Report of Committee on Water Extinguishing Systems

Technical Committee on Automatic Sprinklers

FIG. A-3-9.2

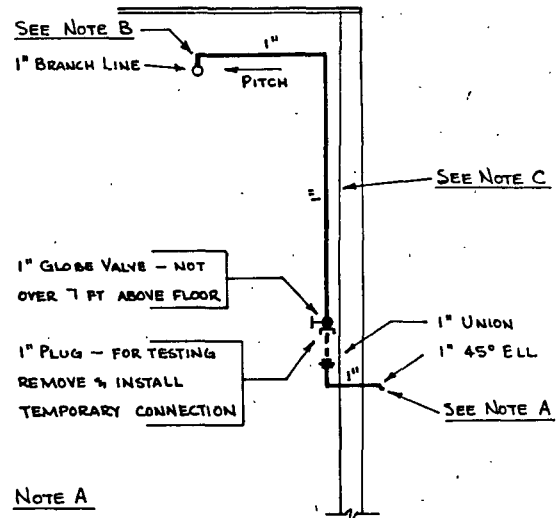
3-9.1 Wet Systems is to remain as is. The asterisks, however, now refer only to the figures in Appendix A: Figures A-3-9.1.1 and A-3-9.1.2. Section A-3-9.1.1 is replaced by A-3-9 (above). Revise 3-9.2 as follows:  
 3-9.2 Dry Pipe Systems. A test pipe of not less than 1 in. diameter terminating in a smooth bore corrosion resistant orifice giving a flow equivalent to one sprinkler shall be provided for each system. To prevent possible loss of system air, the test valve shall be provided with a plug that can be easily removed for system test.  
 Revise Figure A-3.9.2 as shown below:

Figure A-3-9.2

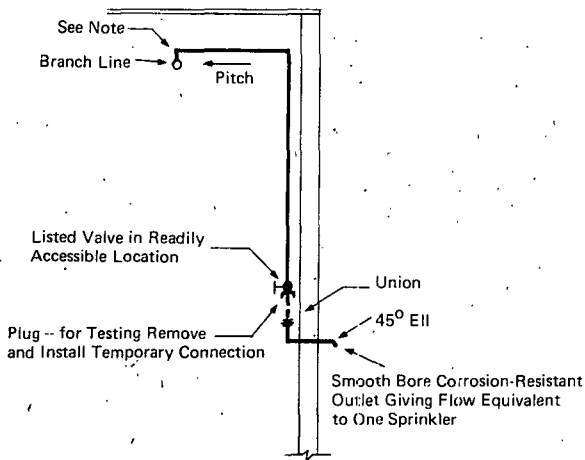
Figure A-3-9.1.2 Delete references to pipe size. Change caption at the union to read, "Union with corrosion resistant orifice giving flow equivalent to the smallest sprinkler orifice in the system." Change sprinkler riser to system riser.

**NOTE:** To minimize condensation of water in the drop to the test connection, provide a nipple-up off of the branch line.

Figure A-3-10.4 Minimum Annular Space.

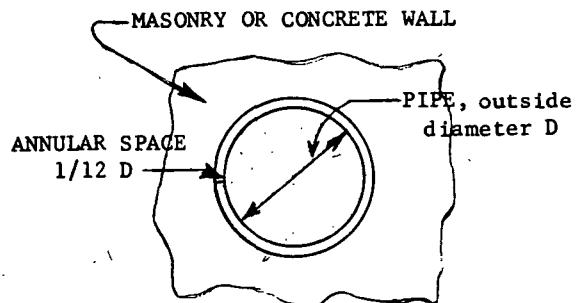
3-10.4\* Protection of Piping Against Damage Due to Impact. The annular space around sprinkler system piping passing through masonry or concrete walls shall not be filled with concrete. An annular space of minimum size 1/12 the outside pipe diameter shall be maintained, or the same size annular space filled with mastic (see Figure A-3-10.4). If the pipe passes through a firewall, the space shall be filled with mineral wool, ceramic fiber, or other compressible proprietary compound held in place with a pipe collar.

Insert Figure A-3-10.4 as follows:

SUBSTANTIATION: Guidance, in addition to that provided specifically for protection from earthquake, is needed. An annular space 1/12 the outside diameter of the penetrating pipe provides adequate space in non-earthquake areas.

Figure A-3-14.2 Examples of Acceptable Valve Arrangements

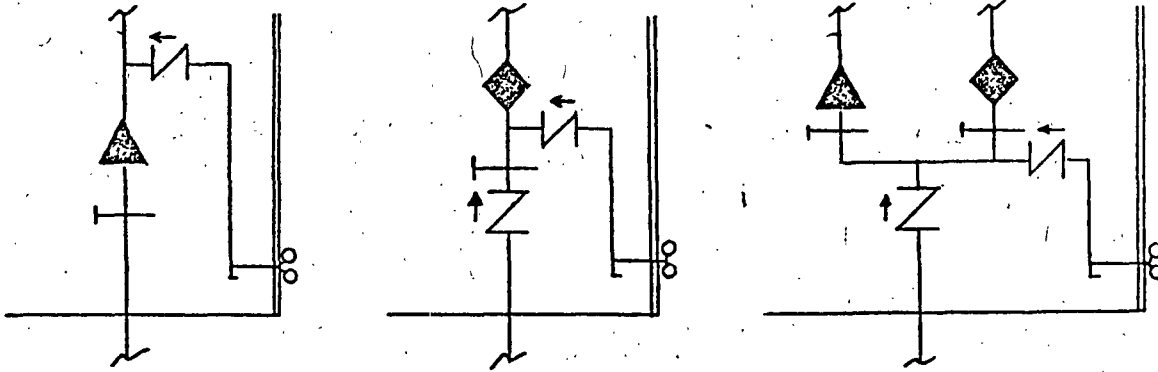
13- 308 - (3-14.2.7 and Figure A-3-14.2): Accept

Add Appendix Figure A-3-14.2 as follows: (See following page for Figure A-3-14.2.)

Figure A-4-4.21 Sprinkler Location in Composite Wood Joist Construction

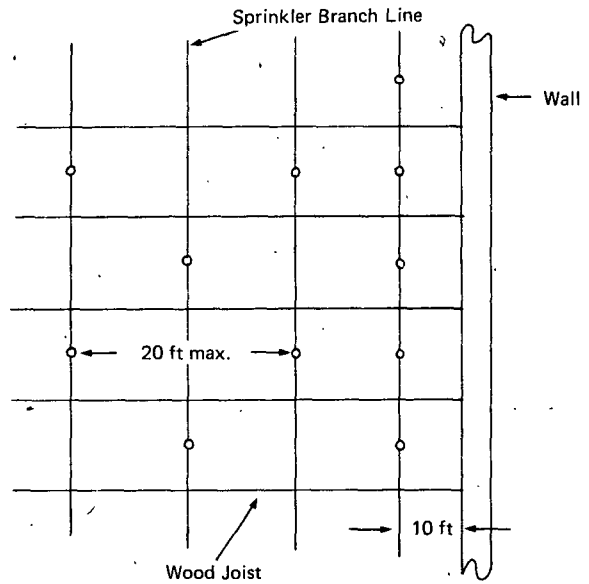
The recommendation does not make sense. We have not described joist spacing depth of beam or beam spacing with respect to defining composite wood joist construction. Apparently there is to be a figure associated with this and nothing is provided.

Add a new Figure A-4-4.21 Sprinkler Location in Composite wood Joist Construction.

**COMMITTEE ACTION:** Accept.

Figure 4-2.5.2(a) Standard Sprinkler Installed Near Privacy Curtain

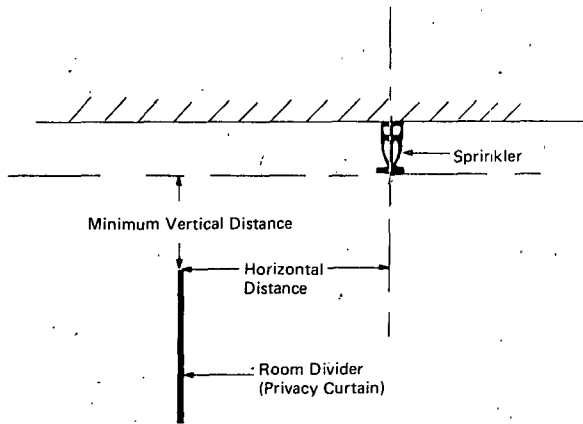
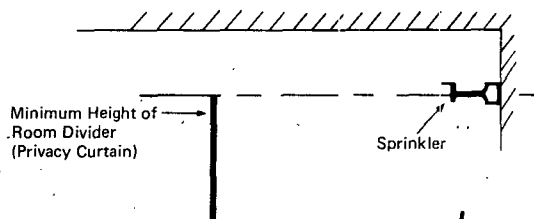
4-2.5.2\* The clearance from pendent and upright sprinklers to privacy curtains, free standing partitions or room dividers shall be not less than the distances given in Table 4-2.5.2 as measured in Figure 4-2.5.2(a). For sidewall sprinklers the top of the privacy curtain, free standing partition or room divider shall not extend higher than the horizontal plane of the center line of the sprinklers as shown in Figure 4-2.5.2(b).

Add Figures 4-2.5.2(a), Minimum Horizontal and Vertical Distance for Pendent Sprinklers, and 4-2.5.2(b), Minimum Height of Room Divider for Horizontal Sidewall Sprinklers.

**COMMITTEE ACTION:** Accept.

Figure A-4-4.8.2.4(a) Noncombustible Stair Shaft Serving Two Fire Sections

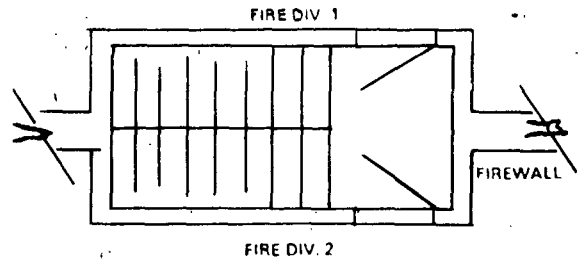
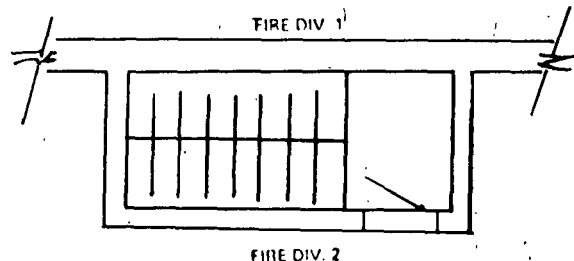
Add to the Appendix Figure A-4-4.8.2.4(a) Noncombustible Stair Shaft Serving Two Fire Sections and Figure A-4-4.8.2.4(b) Noncombustible Stair Shaft Serving One Fire Section.

**COMMITTEE COMMENT:** The revised wording is in accordance with the NFPA Manual of Style and has been renumbered for editorial clarification. The rating of the fire walls for the separation of fire sections is up to the appropriate building code.  
Also see Proposal No. 04 on 4-4.8.2.4.

Figure 5-5.6 Dry Pendent Sprinklers for Protection of Covered Platforms, Shipping Docks, and Similar Areas.

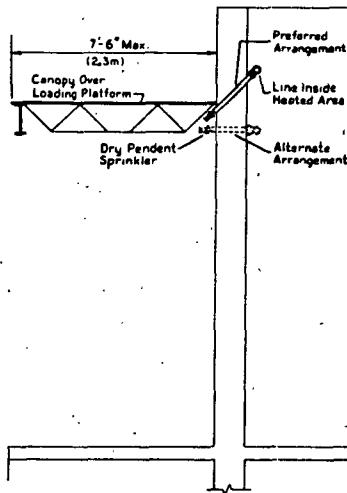
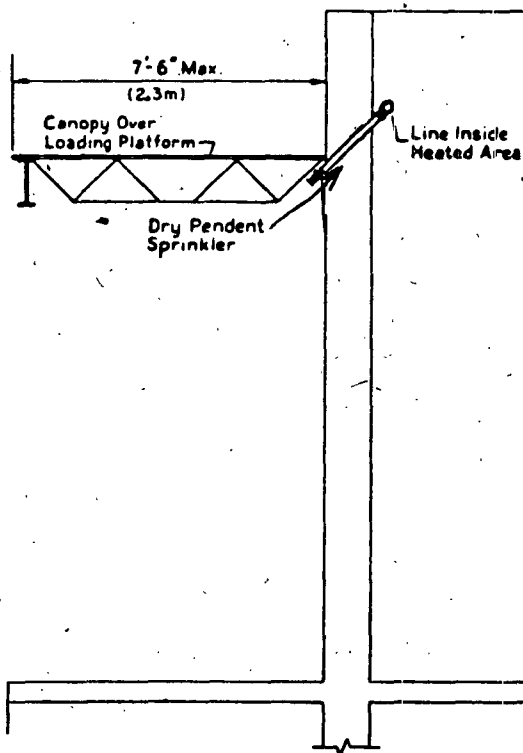
13- P107 - (5-5.6 and Figure 5-5.6 (New)): Accept in Principle  
SUBMITTER: Ron Cote', Factory Mutual Research Corp.  
RECOMMENDATION: Add a new section to read:  
5-5.6 Small loading docks, covered platforms, ducts, or similar small unheated areas may be protected by dry pendent sprinklers extending through the wall from wet sprinkler piping in an adjacent heated area, as shown in Figure 5-5.6.

Add a new Figure 5-5.6

Use the proposal as submitted but delete the alternate arrangement shown on the submitted sketch.

**COMMITTEE COMMENT:** The Committee agrees with the Submitter but is deleting the alternate arrangement because this is contrary to the listing of some dry pendent sprinklers.

Figure A-7-4.3.1(b) Example of Hydraulically Most Demanding Area

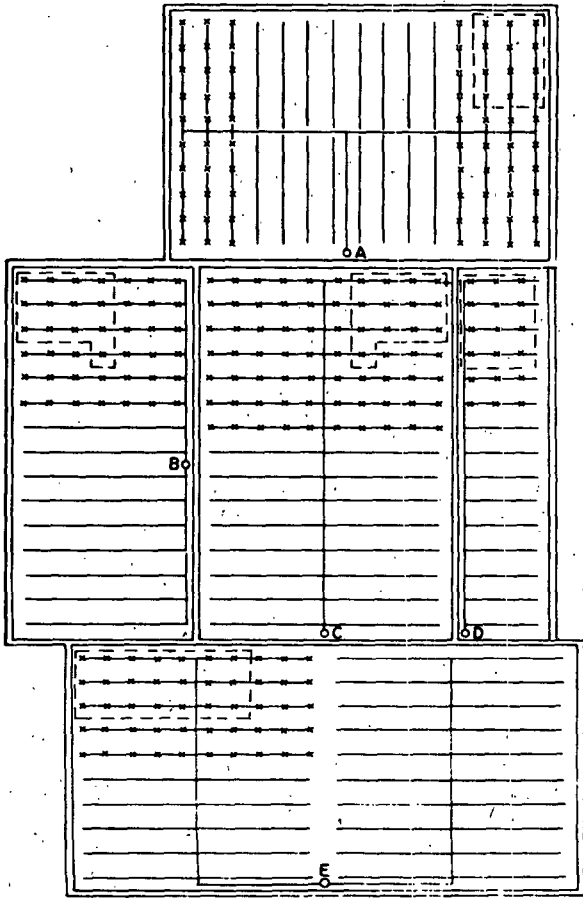
This is not the hydraulically most demanding rectangle required by section 7-4.3.1. I do not believe this was the intent of the committee or Mr. McFadden, but Exception No. 2 could be interpreted to allow it. Adoption of the new section would require extension of the design area parallel to the branch lines, when needed, as follows:

This would provide the hydraulically most demanding rectangle. Also this should not be an Exception but a subordinate section. Exception No. 1 refers to a corridor, a distinctly different remote area, however, Exception No. 2 simply provides a different shape and should be subordinate as I have shown it. The Appendix item provides guidance to the user.

Add a revised Figure A-7-4.3.1(b).

**COMMITTEE COMMENT:** The addition of the new sentence to 7-4.3.1 should clarify the Submitter's intent.

Figure A-7-4.3.1.1(b) Example of Design Area Location.

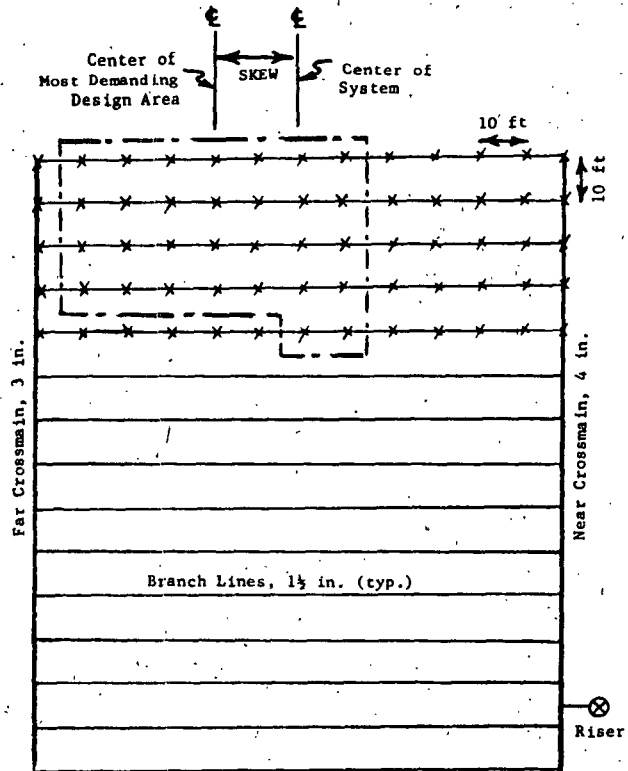
Center of design area is located 2 sprinklers from the center of the system. See Figure A-7-4.3.1.1(b)

Add Figure A-7-4.3.1.1(b).

**SUBSTANTIATION:** A method of locating the design area is needed for situations where the results of three sets of calculations do not definitively locate the most demanding design area. For example, the results of three calculations could be:

Figure A-7-4.3.1.2 Sprinkler Design Area

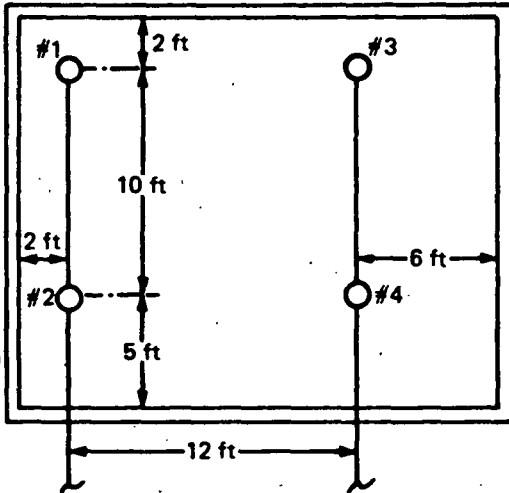
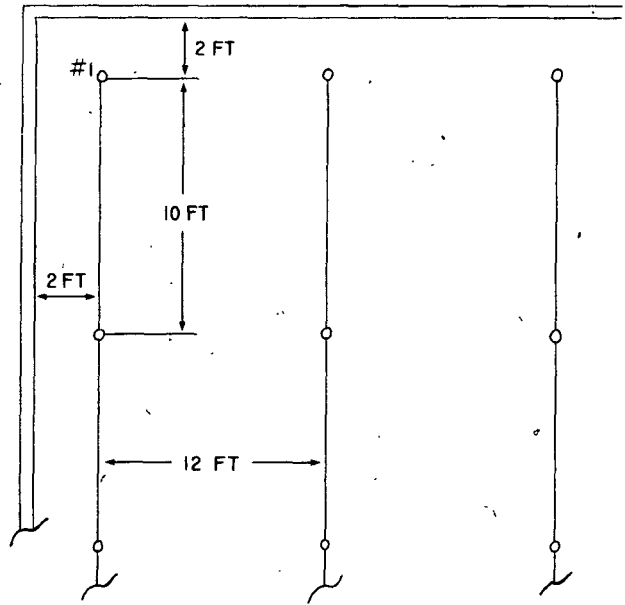
RECOMMENDATION: Reword section 7-4.3.1.2(a)\* to read:  
7-4.3.1.2\* The density shall be calculated on the basis of floor area. The area covered by any sprinkler for use in hydraulic design and calculations shall be determined as follows:

Add a section A-7-4.3.1.2(a) to read:  
Example: Design Area for Sprinkler 1 (see Figure A-7-4.3.1.2)

(a) The density shall be calculated on the basis of floor area. The area covered by any sprinkler for use in hydraulic design and calculations shall be determined as follows:
